**Additional Information Response:**

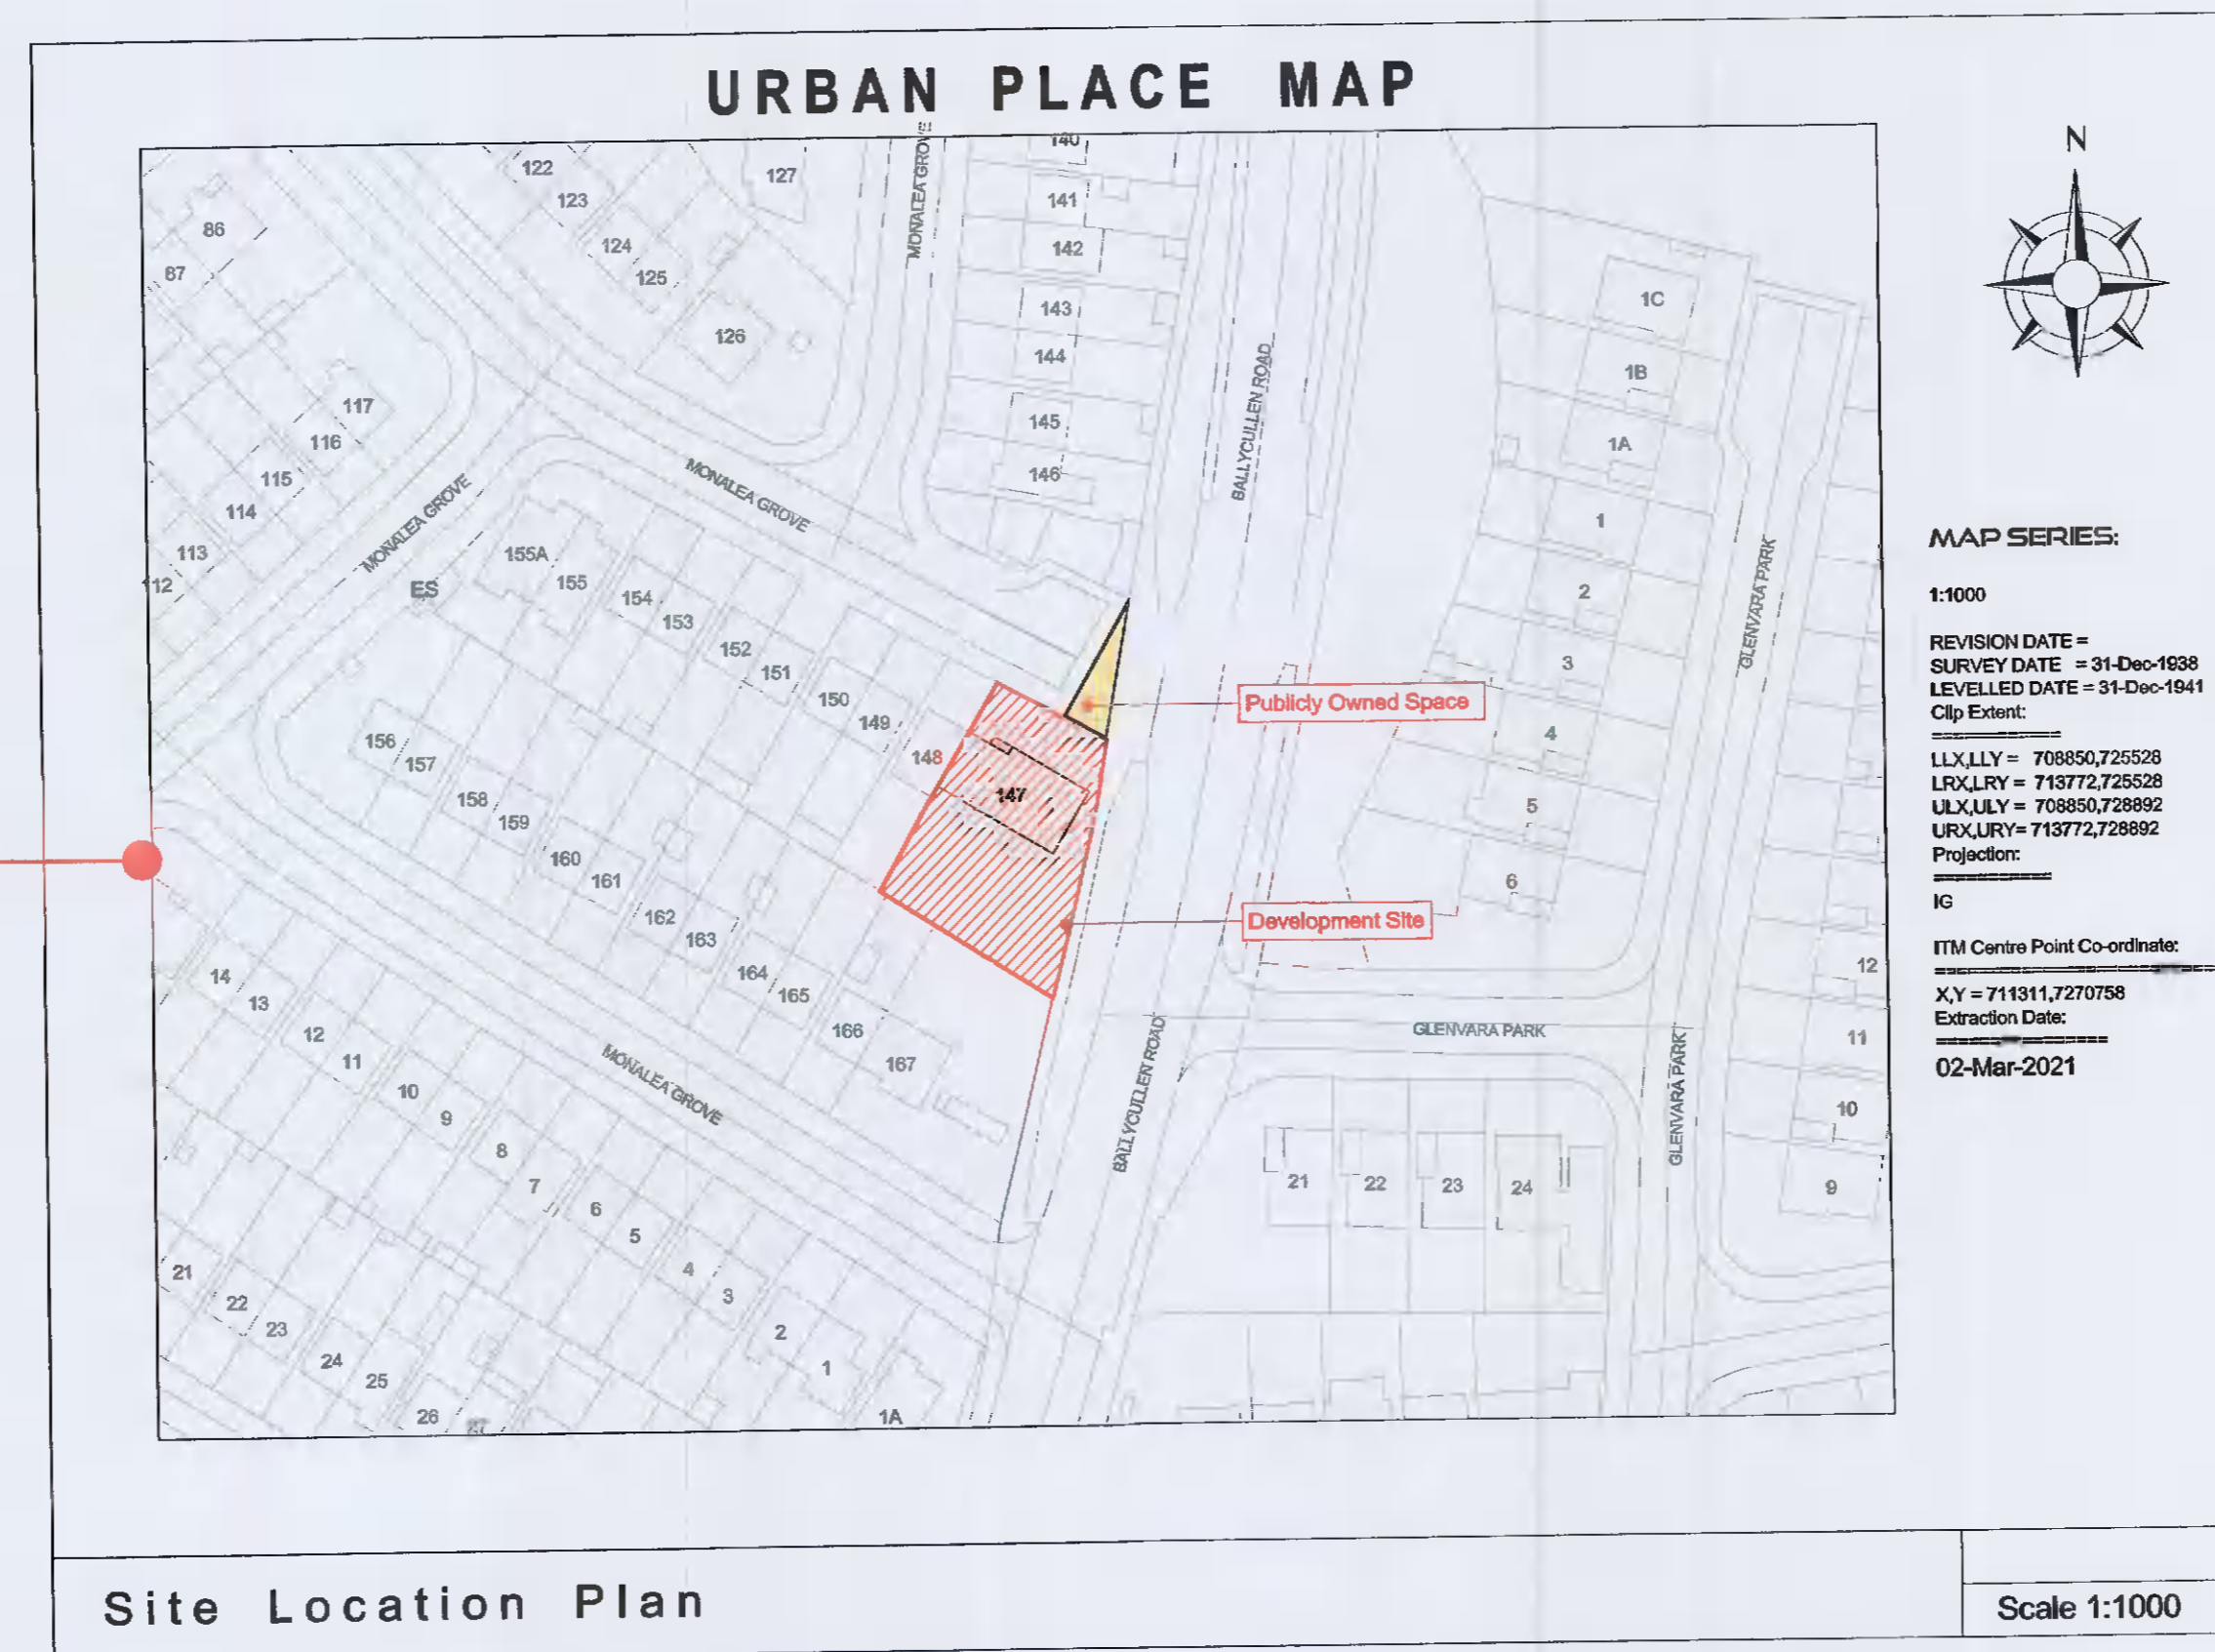
1. Development should not encroach on publicly owned planted space directly north of the site

1. Development does Not encroach on publicly owned planted space directly north of the site  
See Revised Site Layout Plans & Ordance Survey Maps which clearly shows the site boundary line for proposed development and the boundary line for the publicly owned planted space
